Seismic Walkdown Checklist (SWC)

Peach Bottom Atomic Power Station Unit 2
MPR-3815, Revision 3
Correspondence No. RS-12-173

Equipment ID No. 20X133 Equip. Class¹² (04) Transformers

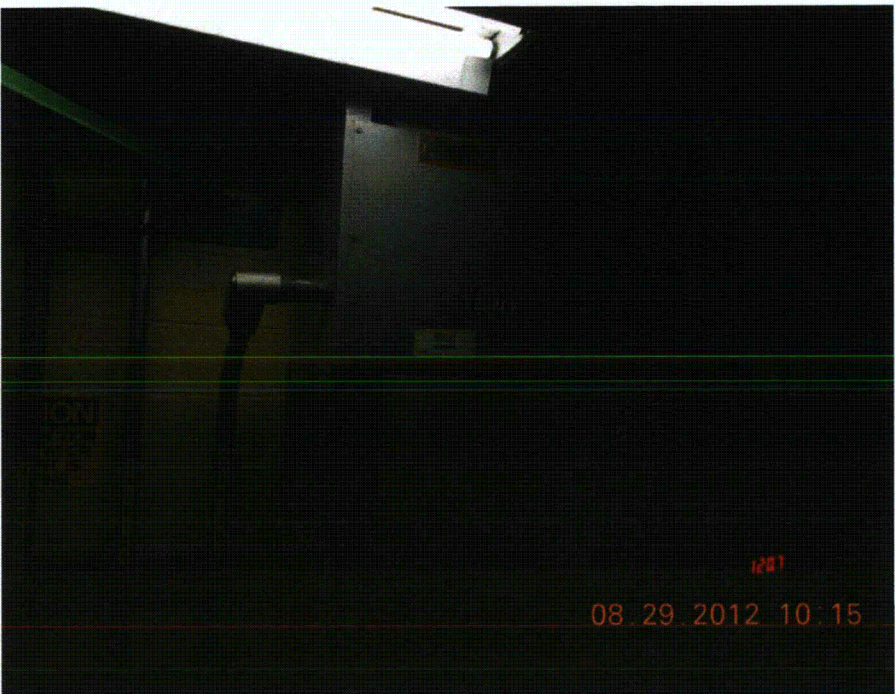
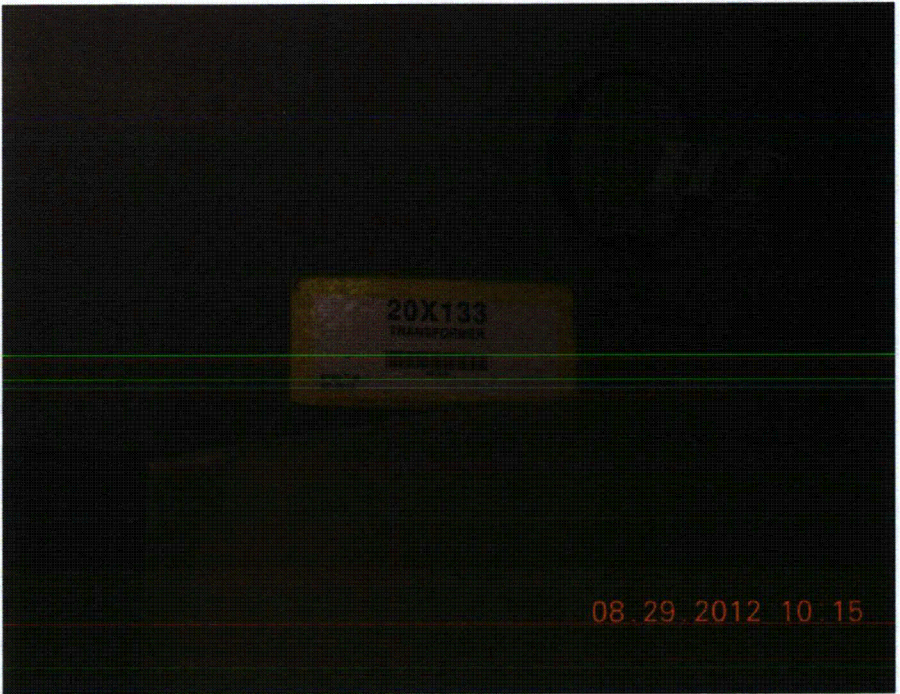
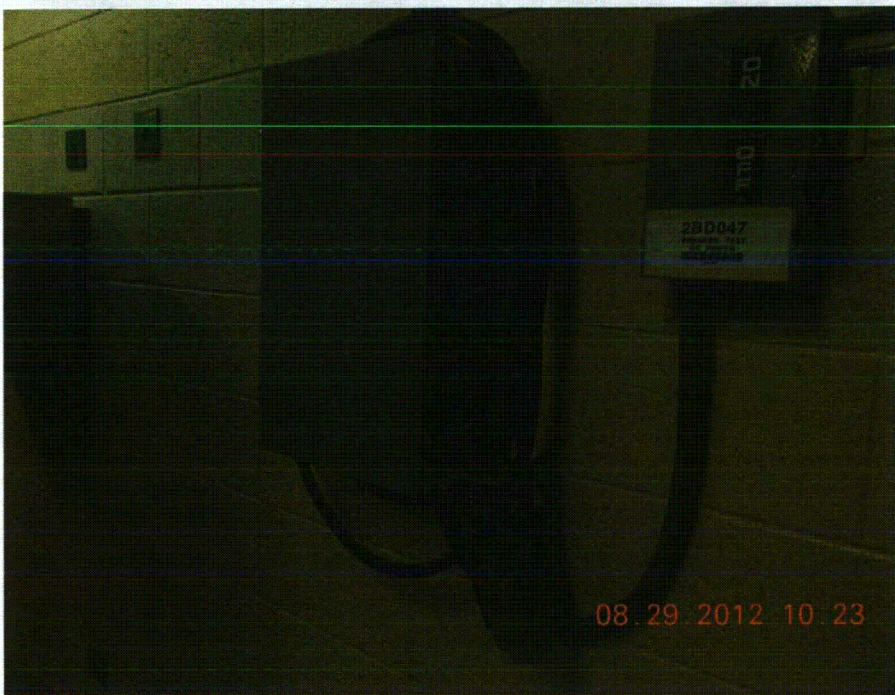
4. Is the anchorage free of visible cracks in the concrete near the anchors?
Anchored to block wall (see #8) Y N U N/A

Block walls reinforced per GOR 8/29/2012 safety-related per PBAPS Specification No. M-701, Rev. 1 (Block wall #s 40-8, -14 and -16) per 9/11/12

Equipment ID : 20X030

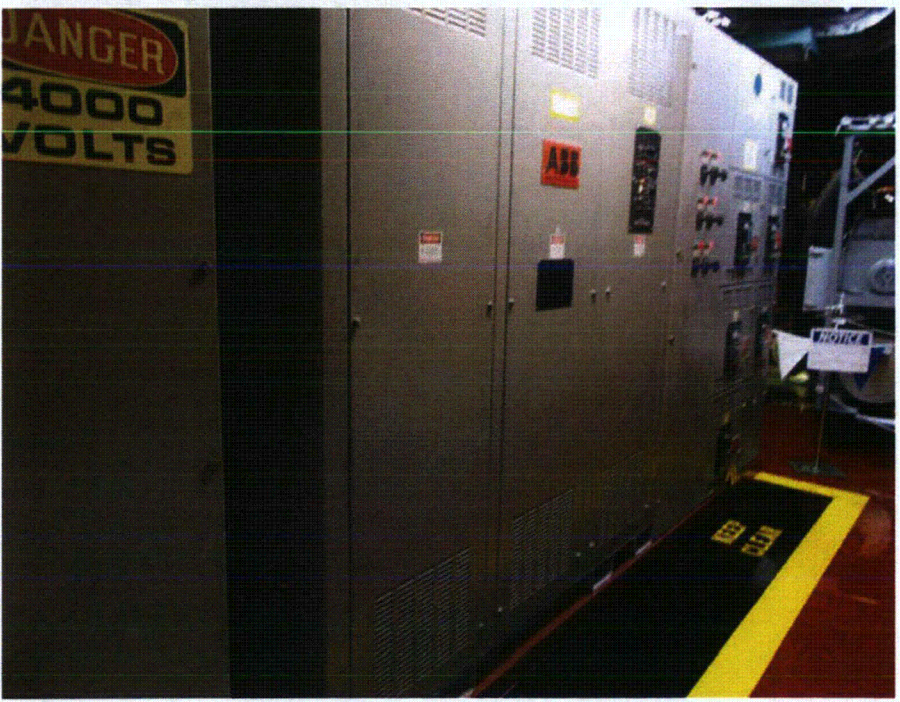
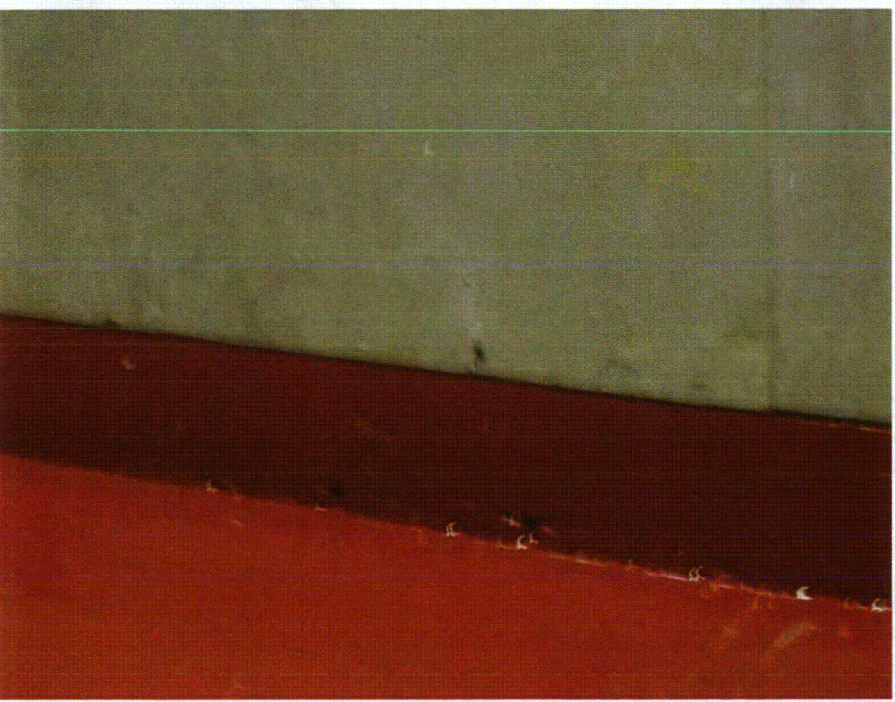
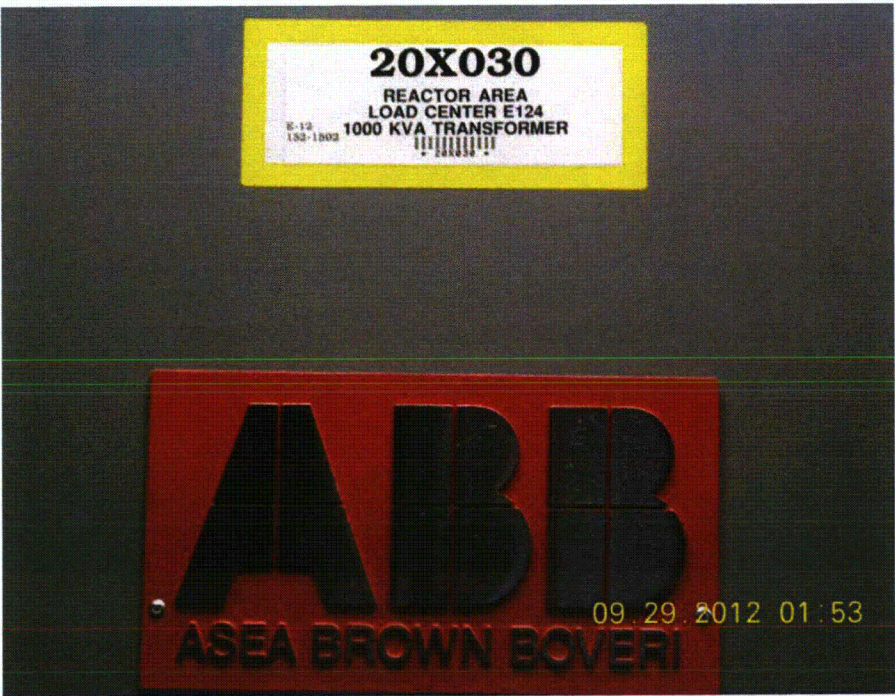
2. Is the anchorage free of bent, broken, missing or loose hardware? Y N U N/A
4 feet welded to channel in floor on each side (front + back)

4. Is the anchorage free of visible cracks in the concrete near the anchors? Y N U N/A
- Minor honeycombing of concrete at south end of pad. No structural impact.

No ceiling tiles, Damage from falling light bulbs not credible. Masonry walls - Component surrounded by block walls 76-6, 76-8, 76-9, 76-10 per PBAPS Drawing S-76 Revision 4. These walls are safety related per PBAPS specification M-701 Revision 1.

No attached lines. Solid ducting to adjacent cabinet.

Equipment ID: 20Y050

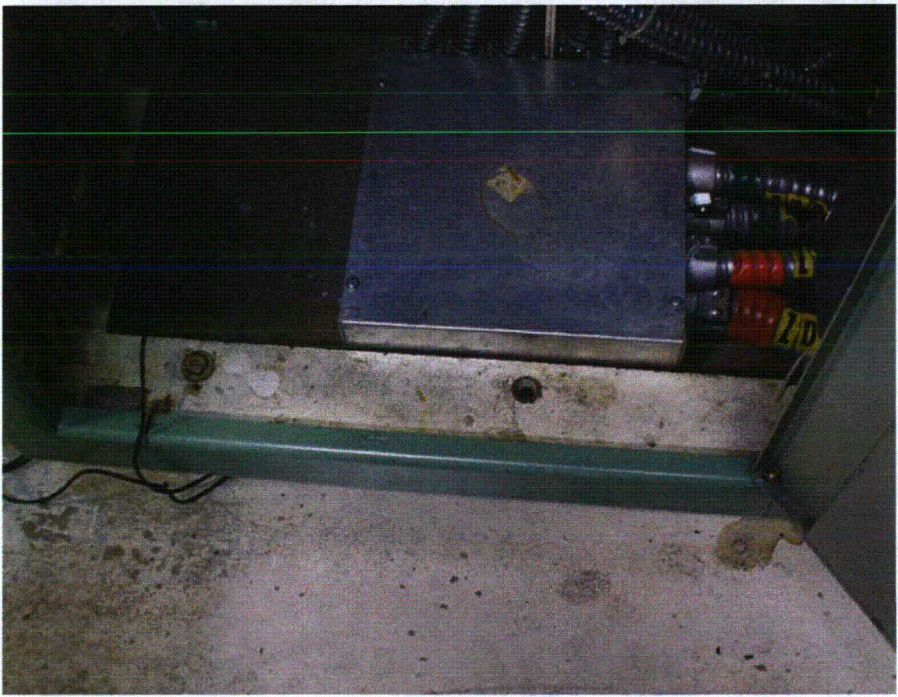
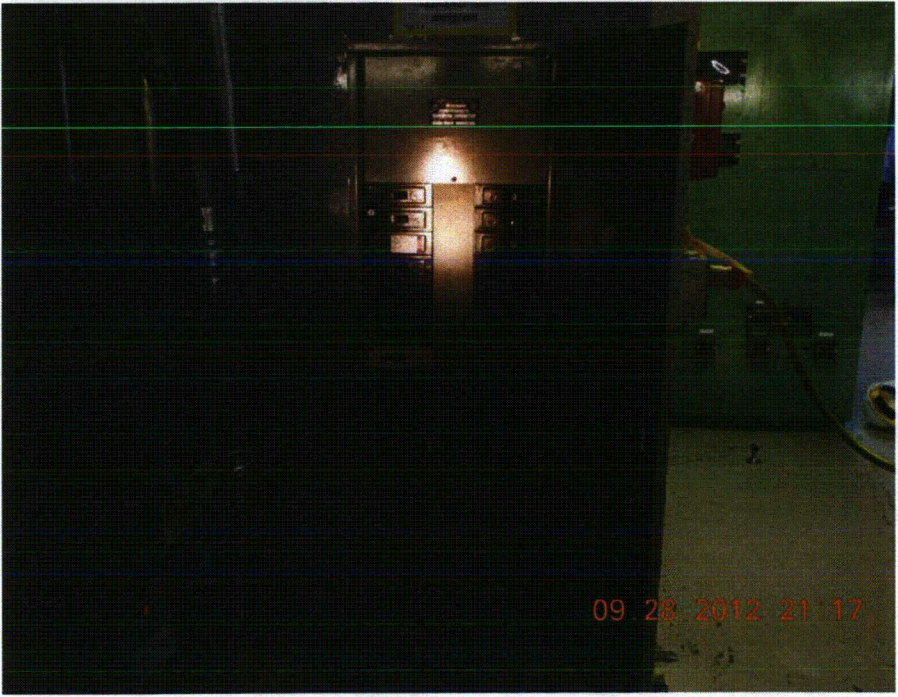
Component attached to masonry block wall. Component attached to wall 68-1 per PBAPS drawing S-68 Revision 33. Wall 68-1 is safety related per PBAPS drawing specification M-701 Revision 1.

Equipment ID: 20Y035

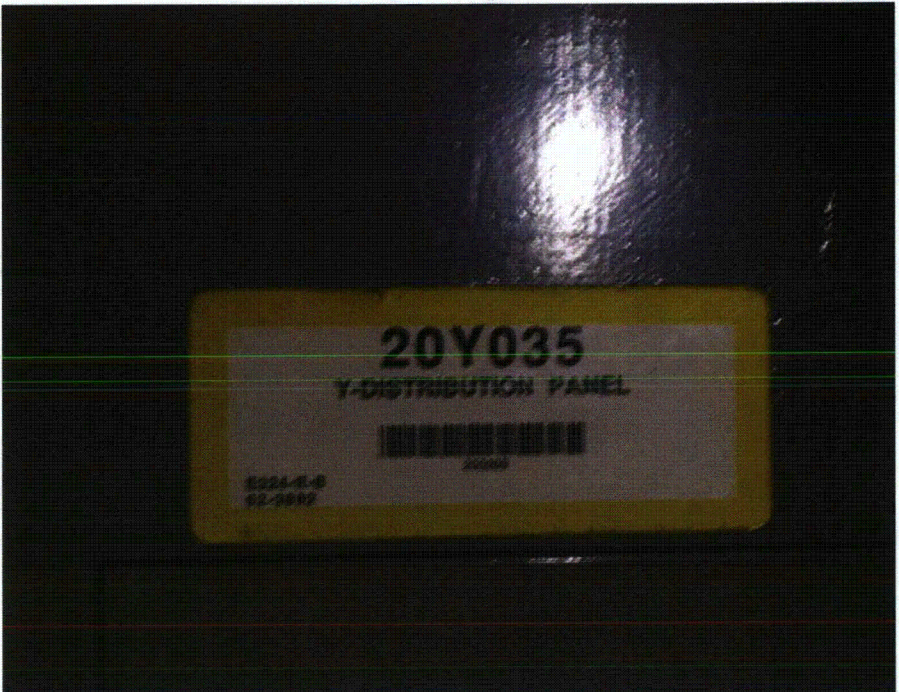
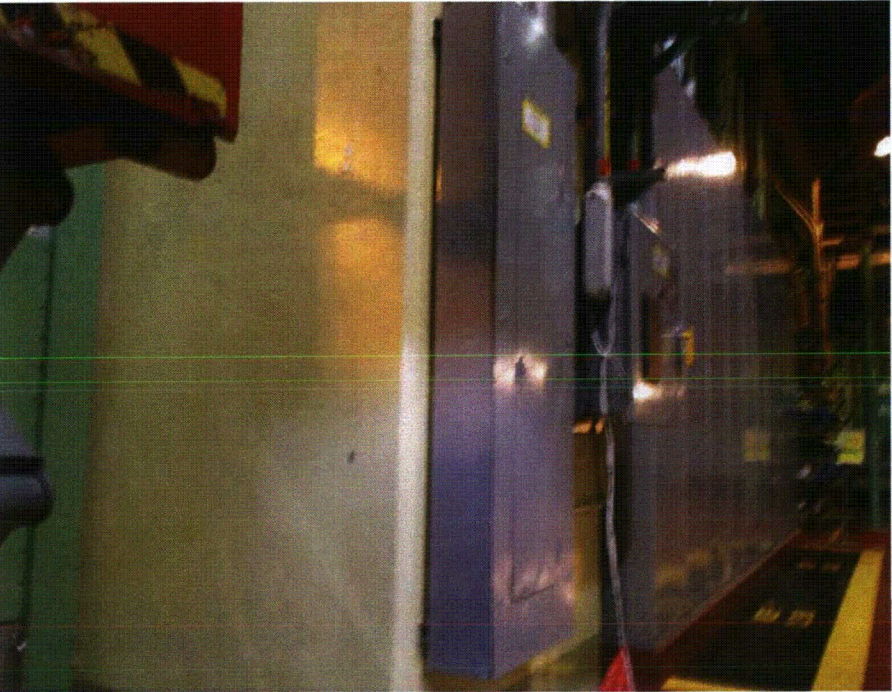
20Y035 is distribution panel in contaminated area. Panel door could not be opened. Cbt 9/25/12

Equipment ID: 2AD001

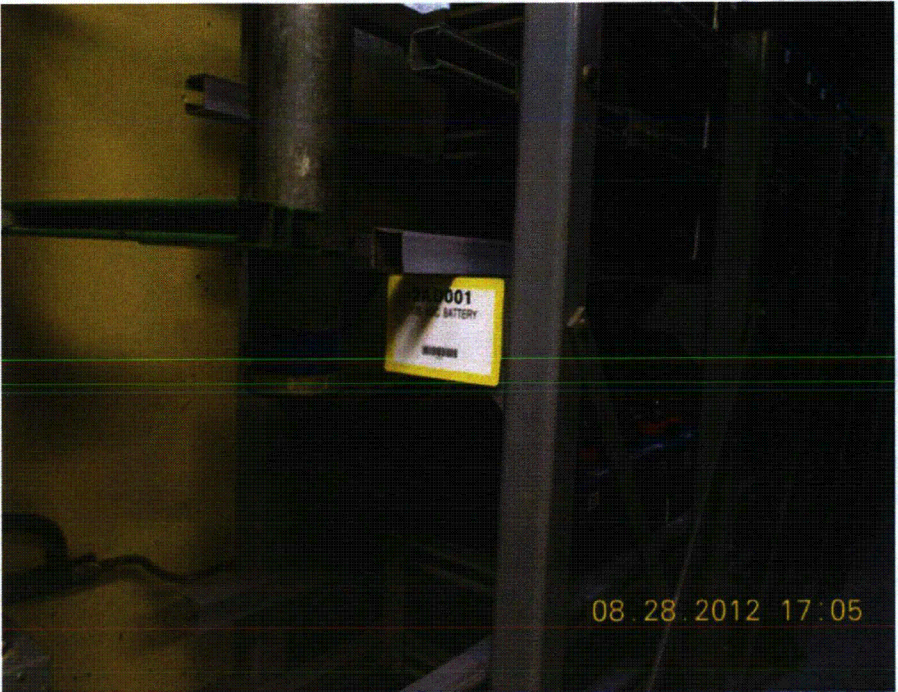
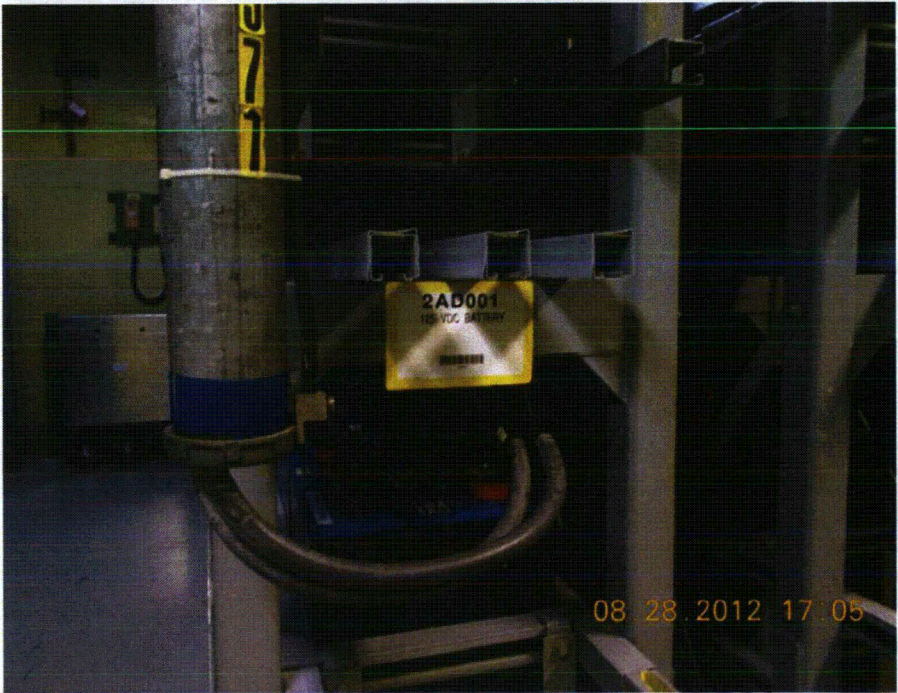
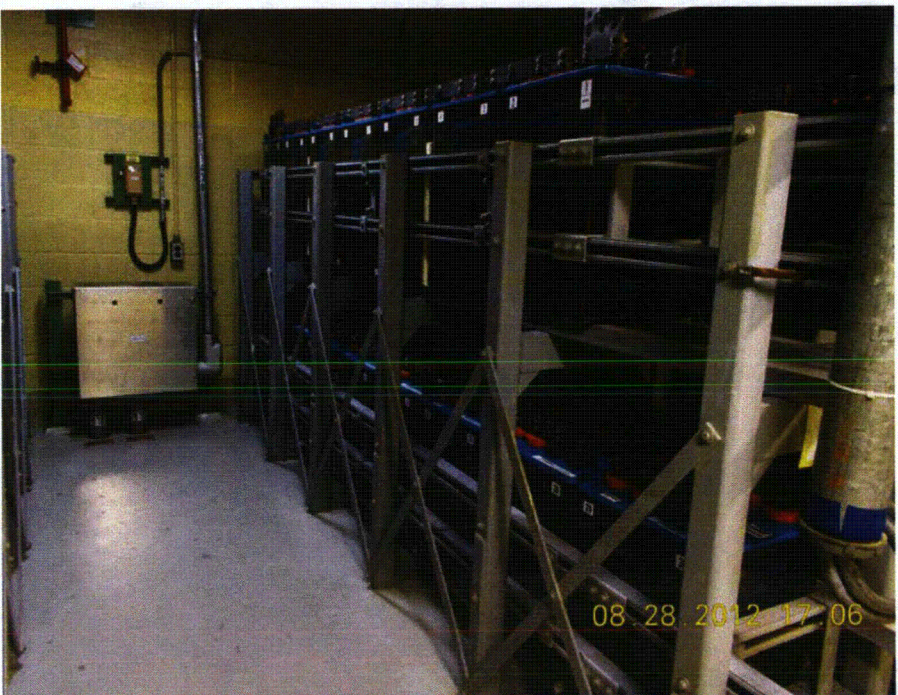
Threaded fire piping is a double-interlock pre-action system (dry piping) per DBD No. P-S-51, Rev. 10

N/A IPSEE: S HOOKS CLOSED PER CR # 207609-25; BATTERIES SNUG BETWEEN END RAILS. KB 10/10/12
